Docket Item # 10
BAR CASE # 2010-0048

BAR Meeting
April 21, 2010

ISSUE: Addition/Alterations
APPLICANT: Alexander St Clair & Julie Egy
LOCATION: 404 Jefferson Street
ZONE: RM/Residential

Figure 4. Photograph of existing and drawing of proposed to illustrate massing.

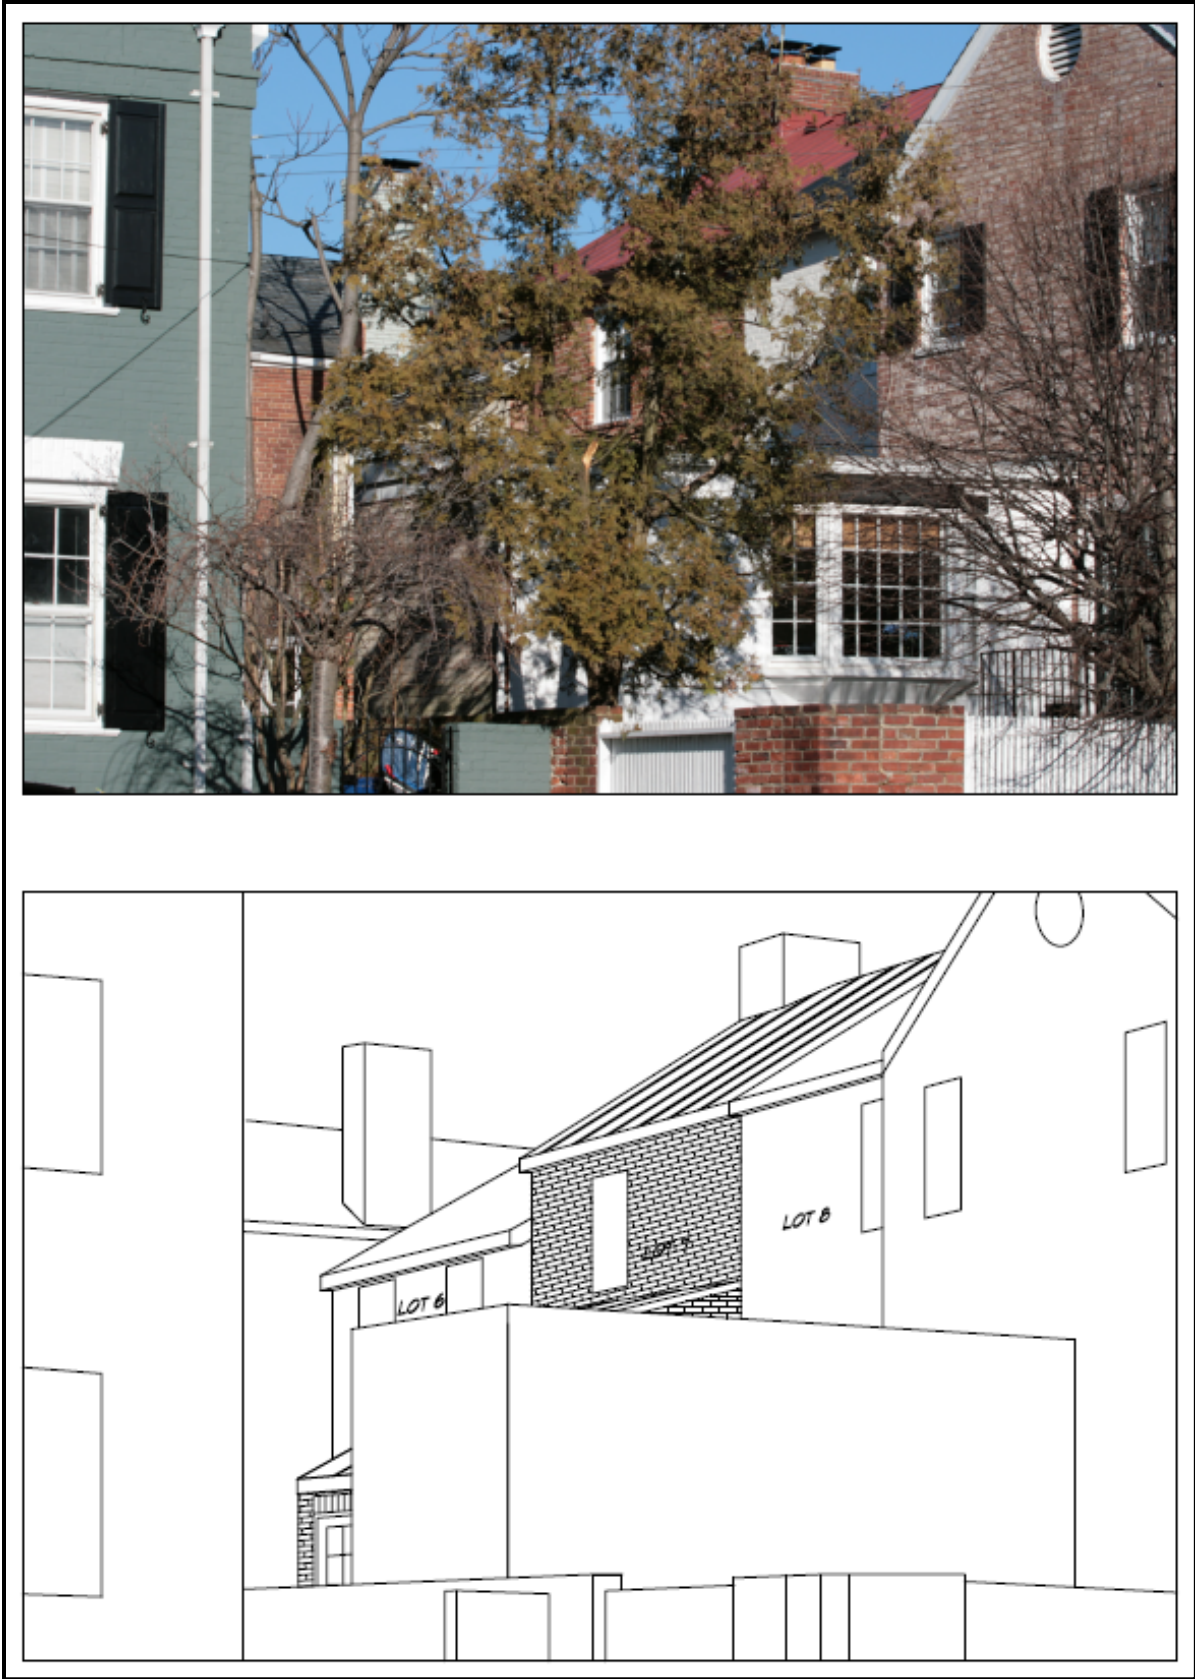
It is the opinion of Staff that the design of the addition is compatible in style and massing to the house, and conforms to the *Design Guidelines* for residential additions. In keeping with the recommendations contained in the *Guidelines*, the addition was designed to be, “compatible with both the existing house and the immediate neighborhood.” The addition is relatively small in size and does not overwhelm the existing house or adjacent properties. Indeed, it is well proportioned and a substantial improvement to the architectural character of the rear elevation of this home.

404 Jefferson Street is the third from the end in a row of five adjoining rowhouses on Jefferson Street to the west of Royal Street; the proposed addition is only minimally visible from S Royal Street. In Staff’s opinion, due to the compatibility in design of the proposed addition and its minimum visibility from the public right-of-way, Staff recommends approval of the application.

STAFF RECOMMENDATION: Staff recommends approval of the application as submitted.

Figure 5. Elevation of proposed addition.

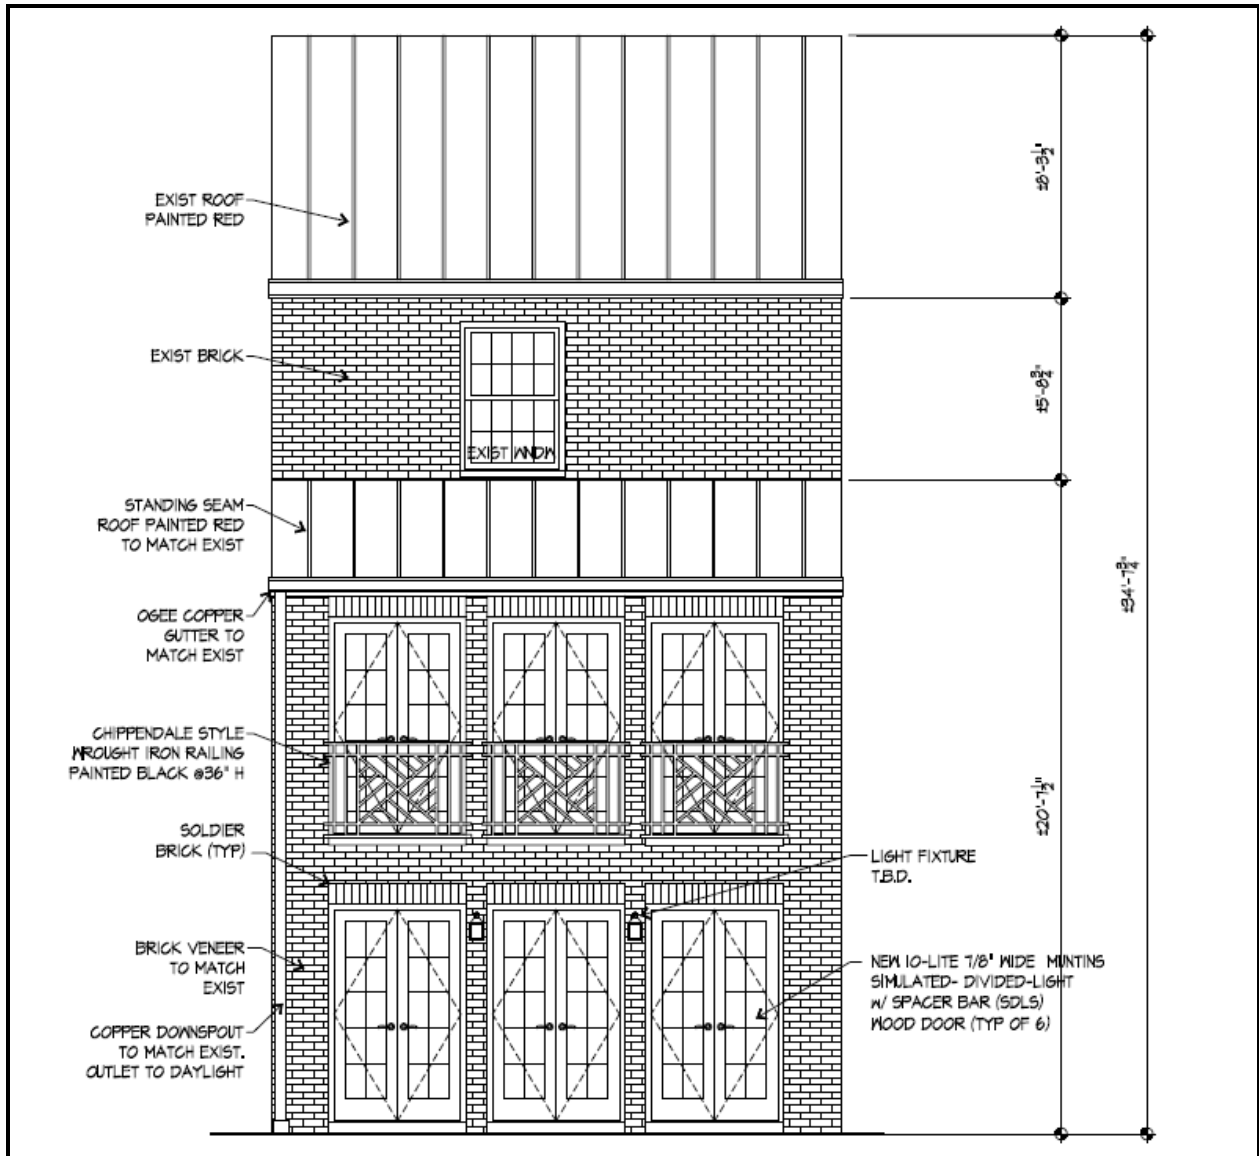
While single-glazed, true-divided-light wood windows are preferable, the *Design Guidelines* and the Board generally allow for double-insulated, simulated divided light wood windows and doors on new construction or in areas with limited visibility, both of which apply in this case.
